RESPONSE TO L R D OPINION L R D PLANNING APPLICATION

KNOCKRABO PHASE 2

Project: Knockrabo Phase 2
Location: Mt. Anville Road, Dublin 14
Client: Knockrabo Investments DAC
Doc. Title: Response To L R D Opinion
Doc. No.: 1307G-OMP-XX:XX-PP-A-6003

Proj. No.: 1307G
Proj. Lead: SD
Created by: SD
Doc. Purpose: A3 - LRD Stage 3 Submission
Revision: C03 (23-10-2024)

Detailed section and specificatoin from apartment Blocks A, B, C & D, Phase 1, Knockrabo

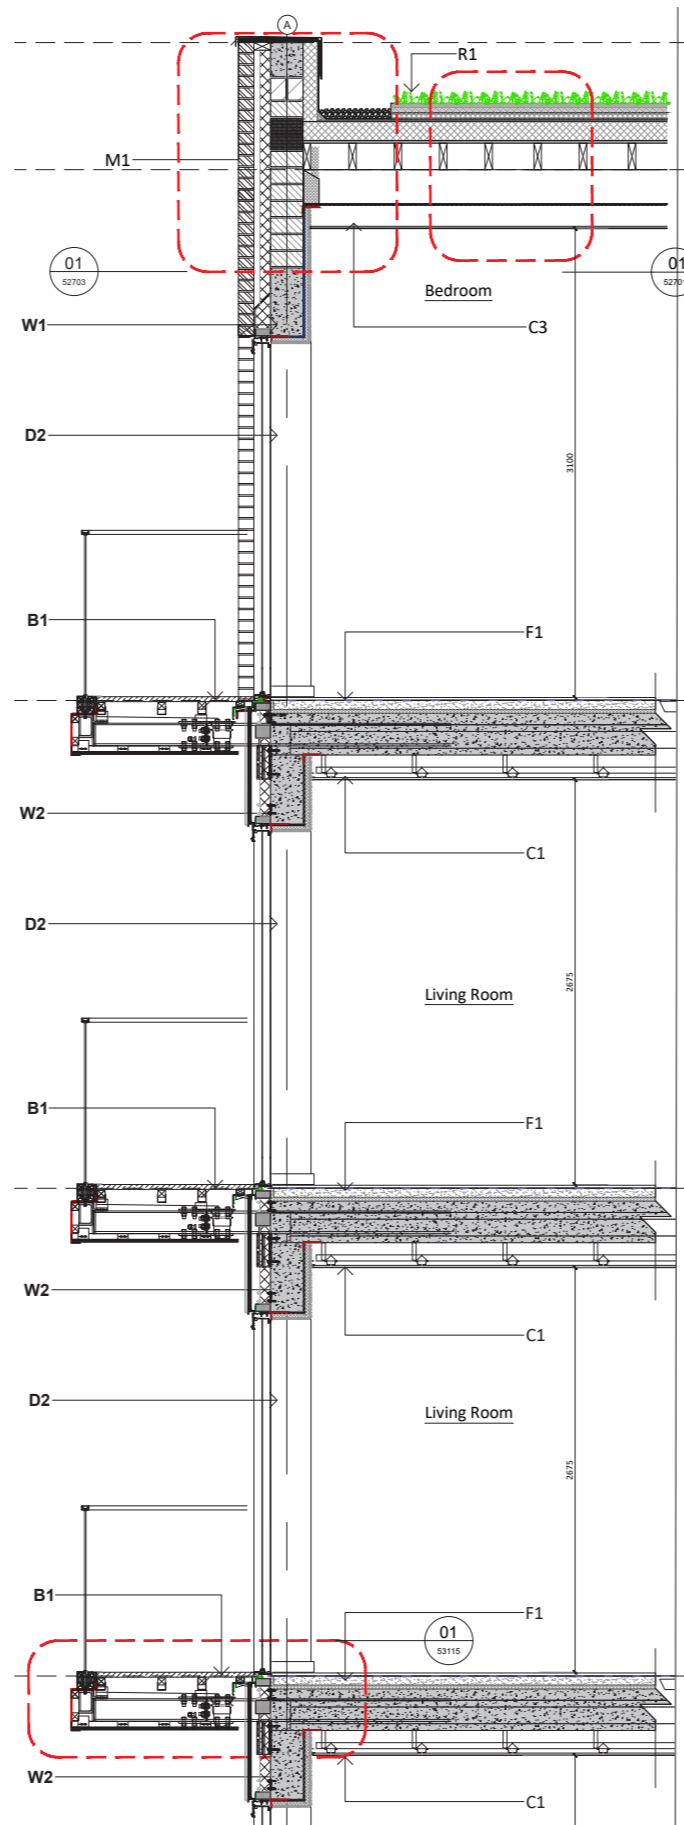
Item 1 of the Opinion requests a report that addresses the proposed materials and finishes to the scheme, including specific detailing of finishes & the treatment of balconies in the apartment buildings.

The proposed apartment buildings carry through the material palette, detailing and specification from apartment Blocks A, B, C and D of Phase 1 of the Knockrabo development as constructed, with a combination of red and white brick to the predominant facades and limited use of grey metal cladding to penthouses and recesses.

Material Key

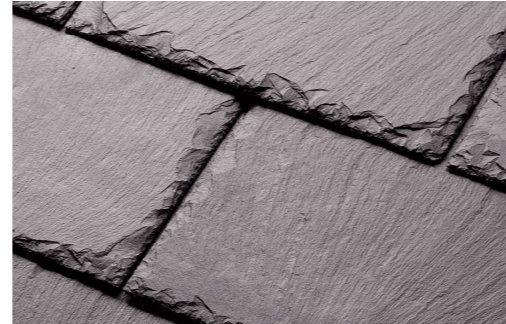
Item 1 of the Opinion notes the need for justification/rationale for mix, variation or otherwise of external finishes between Protected Structures and any relevant similar heritage structures.

As noted in the Architectural Design Statement, the subject LRD application includes works to Cedar Mount House (Protected Structure), Gate Lodge West (Protected Structure) & the Coach House. The proposed works to these buildings are identical to those that were permitted under D17A/1124, which were designed by Howley Hayes Conservation Architects.

In all three buildings, the designs have been carefully considered to clearly distinguish between historic fabric and contemporary interventions, in line with conservation best practice. The palette of proposed materials is illustrated above, and is identical to those that were permitted under D17A/1124.
